DS-K1T331 Series MinMoe Terminal

Release Notes (2021-02-08)

Device Model: DS-K1T331 DS-K1T331W	Firmware Version	ACS_331_AI2_EN_STD_V3.2.0_build210203 ACS_331_AI2_EN_NEU_V3.2.0_build210203
	SDK	Latest baseline
Naming Rule: W for WIFI	iVMS-4200 Client Version	Latest baseline

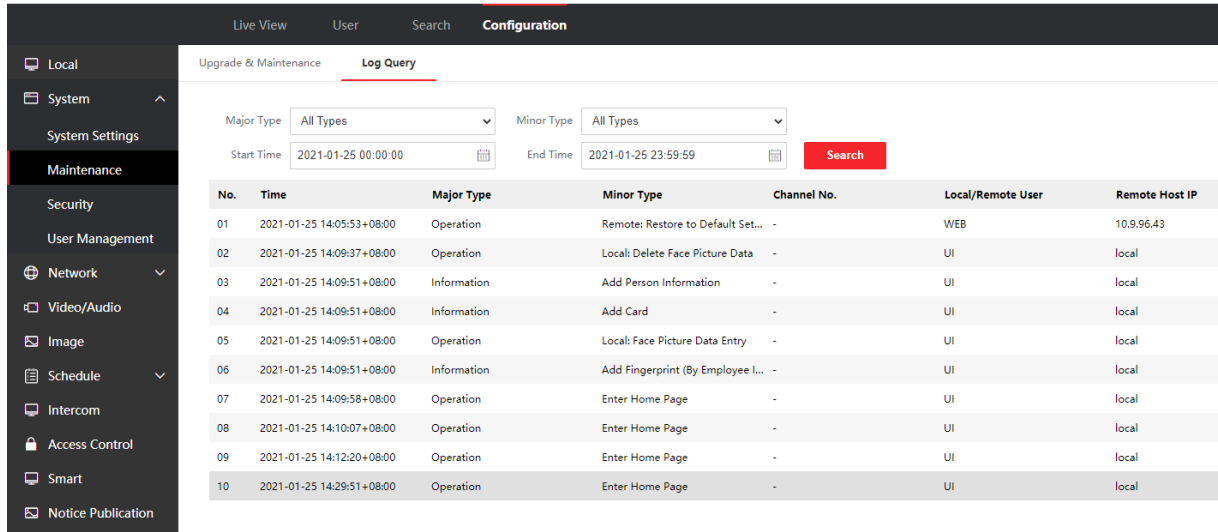
2. Support English, Spanish (South American), Arabic, Thai, Indonesian, Russian, Vietnamese, **Brazilian Portuguese**
3. Support https feature

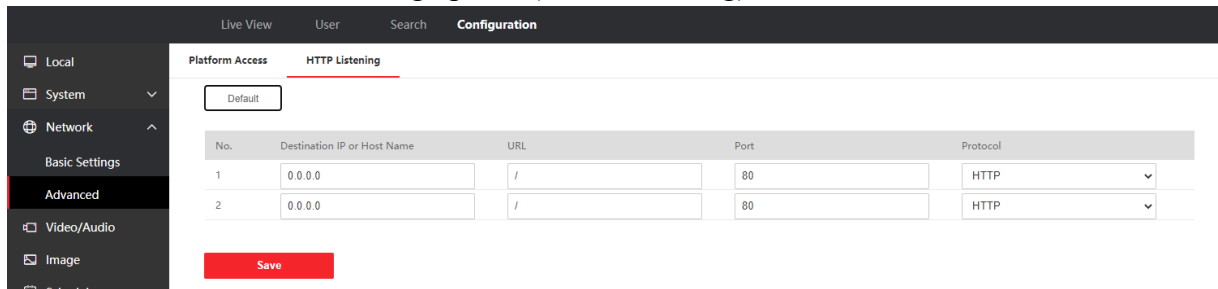
4. Add Hik-ProConnect platform docking
5. Add device operation log query function

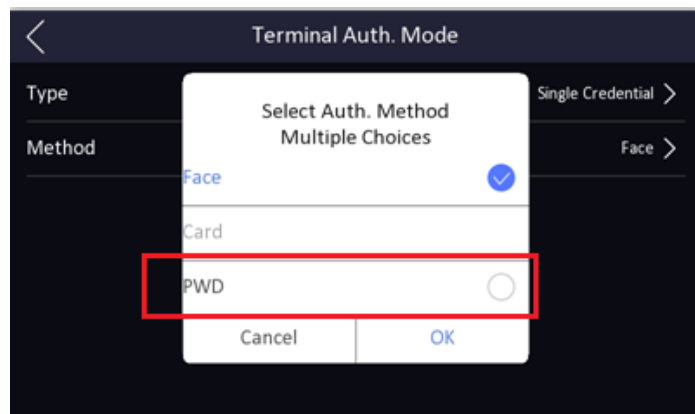
7. Support PIN code to open the door (disabled in default),

Note: PIN code should be configured from software, iVMS4200 already support, HikCentral Pro will support PIN code configuration in V2.1 expected to be released in June

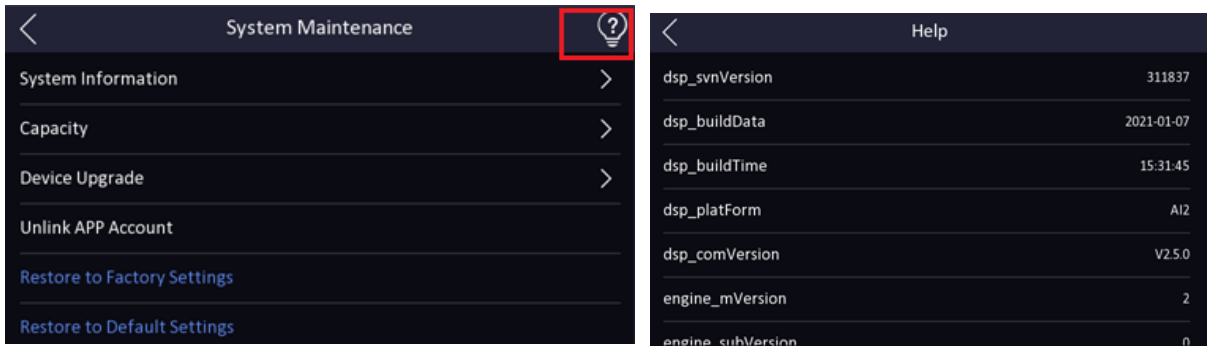
8. Support unbind device with hik-connect account on SADP tool, local UI and web interface

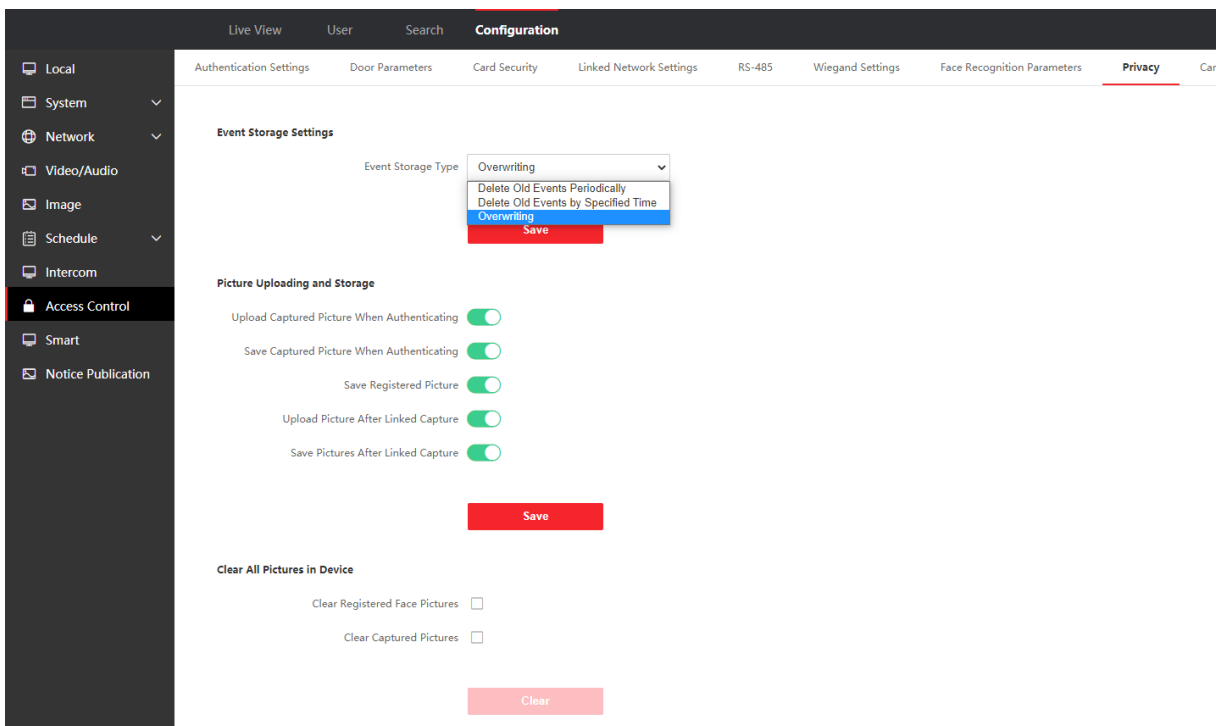
9. Add help interface to check system module version for technical support (long press for 3s).

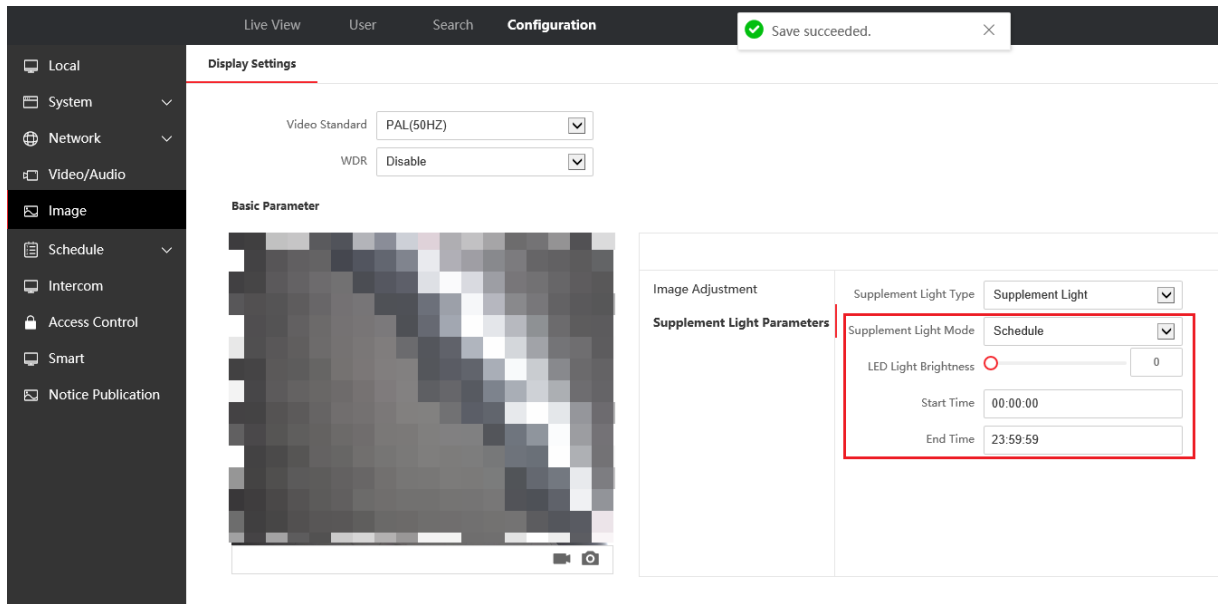
10. Add privacy protection, customer can define the privacy related parameter, such as Event Storage Settings, Picture Uploading and Storage, Clear All Pictures in Device

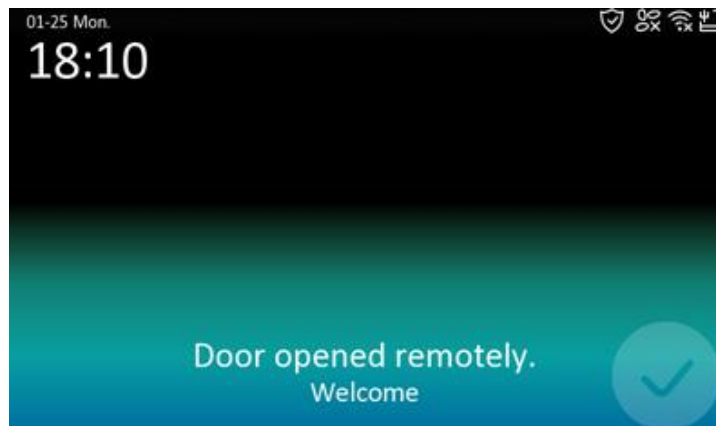
11. Configure the time period when the white supplement light is turned on and off in device local menu or web interface

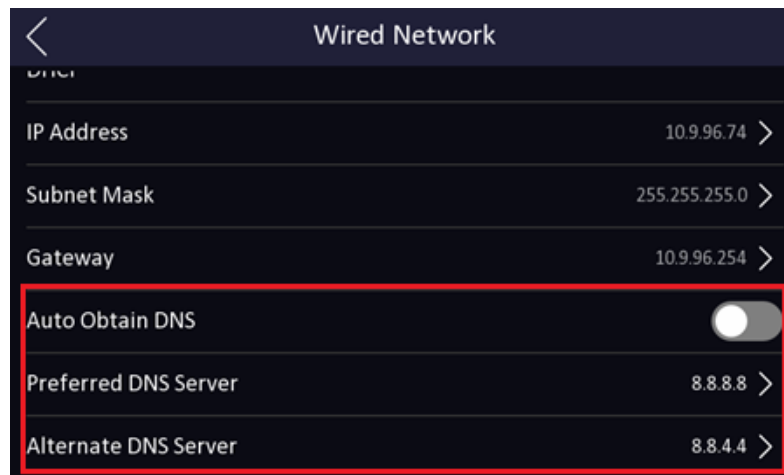
1. Hik-Connect function is turned off in default for privacy protection, if customer want to manage device from App, please turn on manually in the web.

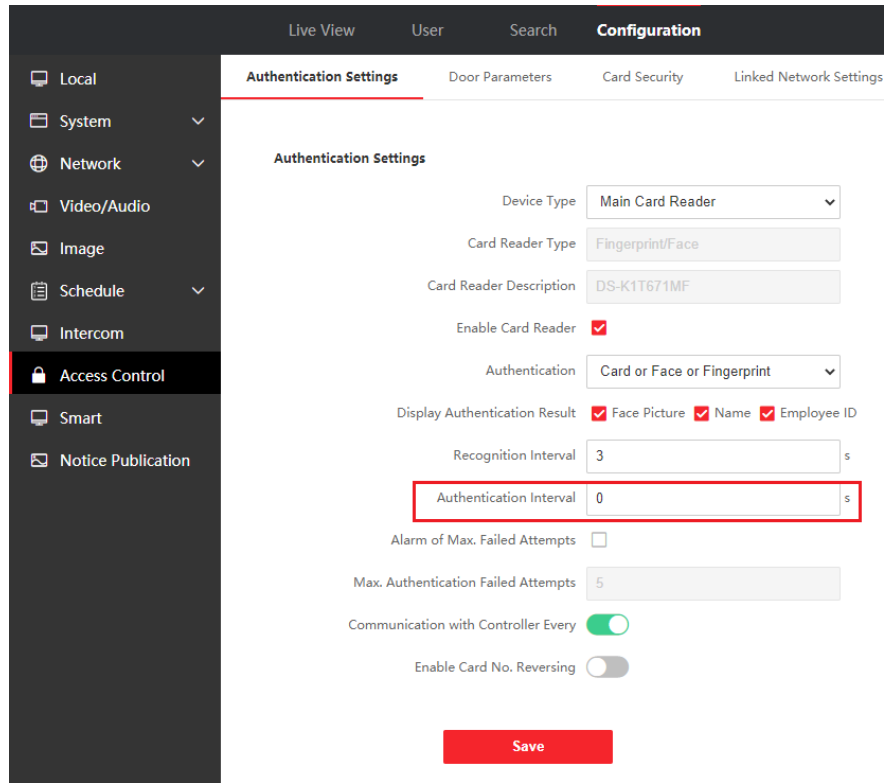
2. The face matching algorithm is upgraded. Improve the speed and accuracy of face recognition.
3. DNS can be configured from device UI in menu → Comm.-->Wired Network

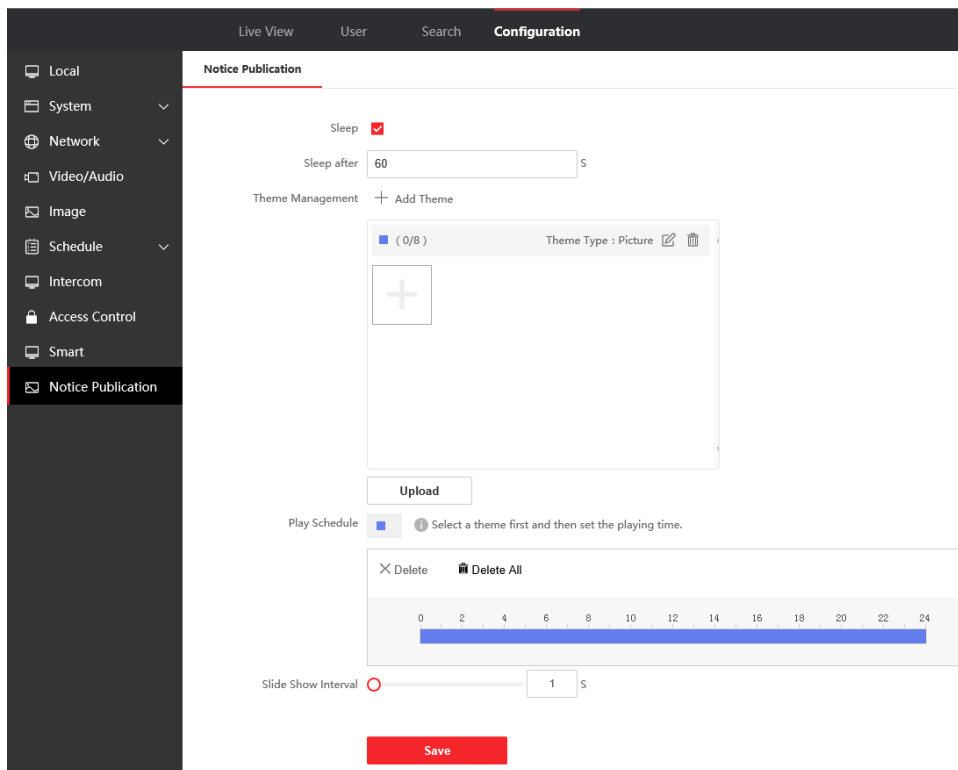
4. Optimized the ISUP and Hik-Connect event upload mechanism.
5. Add stranger authentication timeout time configuration
